Subject: RE: Newbattle Terrace Public Realm

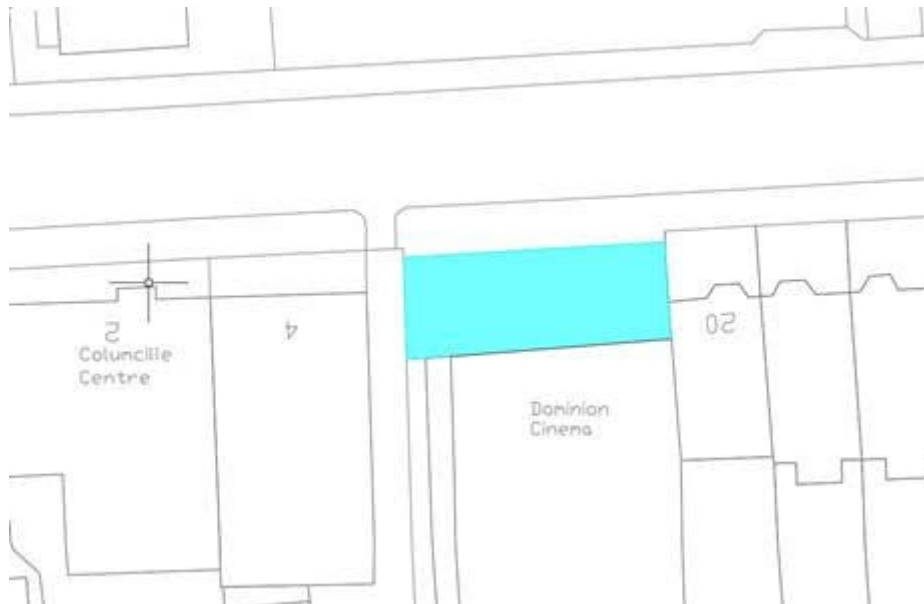
- Cycle lockers: This is not within the scope of this scheme. I will forward this suggestion to the Active Travel team.
- Car Club: That is not within the scope of this scheme. I will forward this suggestion on to the Council's Car Club liaison.
- Disabled parking bays: These must conform to the layout specified in the Traffic Signs Regulations and General Directions 2016 to be legally enforceable.
- Electric vehicle charging: charging points will be mounted on a lighting column on the footway.
- Footway parking at the Dominion cinema: The cinema owns the strip of land between the rear of the footway and the cinema frontage (see highlighted area in the diagram below). As such, the owners and staff have a legal right to access and park on their land.
